Application for "Other Business" APR 11 2017 Cobb County, Georgia

Commission District: 19th Zoning Case: Z-51 of 2016

Location: 3204 Macland Road Powder Springs, GA 30127
(street address, if applicable; nearest intersection, etc.)

State specifically the need or reason(s) for Other Business: revise DDT -
recommendations from zoning review. Remove
curb & gutter recommendation along Macland Rd from
DDT comments.

CONCEPTUAL SITE PLAN FOR
3204 MACLAND ROAD
 LAND LOT 49, 19TH DISTRICT, 2ND SECTION
 COBB COUNTY, GEORGIA

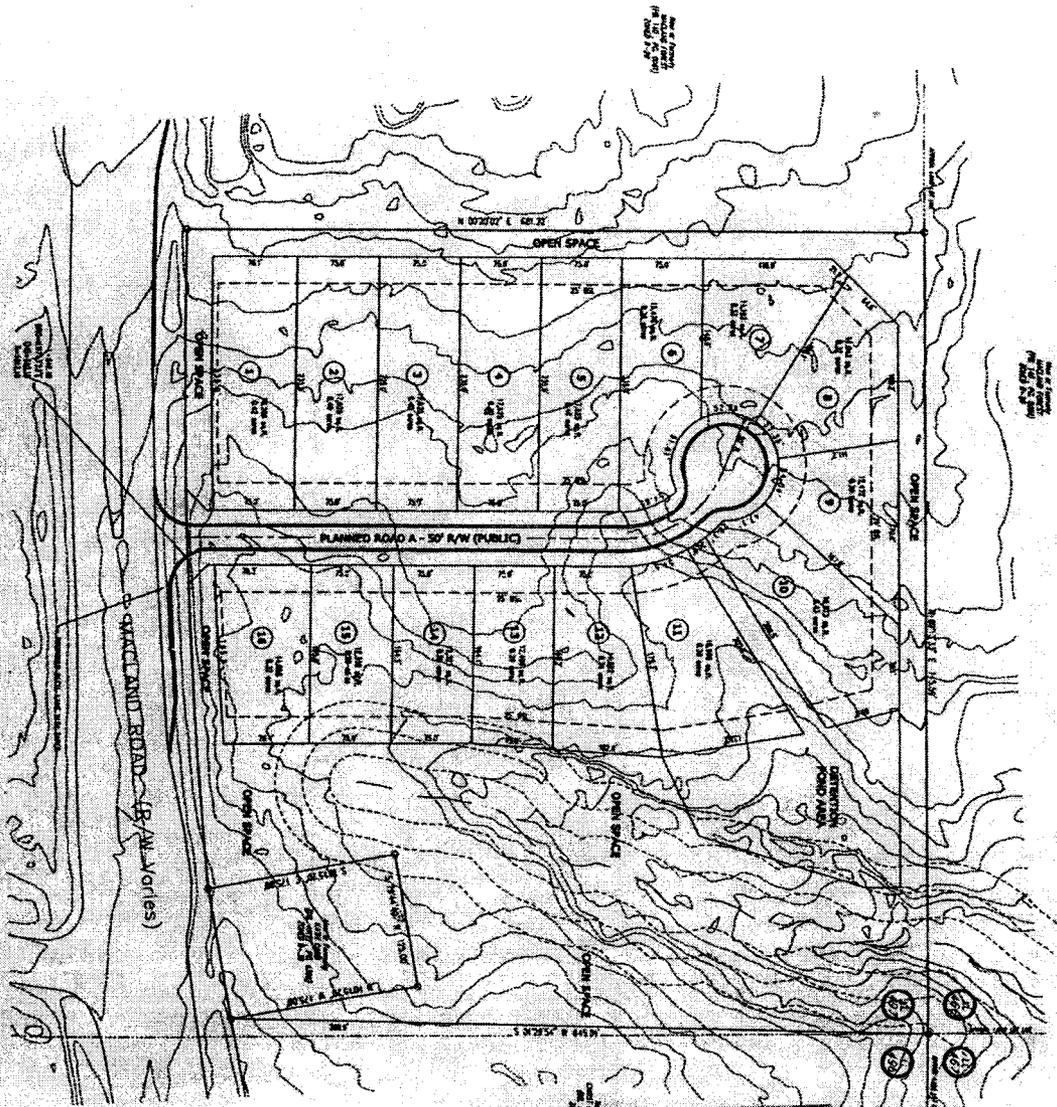
Development as proposed on revised site plan received on 05/18/16 does meet the technical requirements of the OSC ordinance and the required percentage of open space that allows a density bonus up to 1.92 units per acre for an R-20 OSC. To further enhance this proposal the following comments and recommendations should be met.

1. Remove the small portions of lot 14 and 15 that encroach into the 50' stream buffer. The OSC ordinance requires all stream buffers to be in open space.
2. Must have Cobb Department of Transportation approved lighting plan in if outdoor lighting (except individual residential lots) is proposed
3. A Conservation Easement must be recorded in the mandatory subdivision covenants and with Cobb Superior Court, thereby protecting the "Open Space" from development in perpetuity as

4. Provide stipulation letter that describes in details the proposed development.
5. For all lots contiguous to open space it is recommended to include a deed during sale of homes so that future lot owners are aware that commonly owned open space exists adjacent to their property and cannot be built on or disturbed.
6. As another form of privacy barrier staff recommends installing fence (split rail or any fencing compatible with architecture/landscaping/design of development) to the rear/side of lots that are adjacent to open space
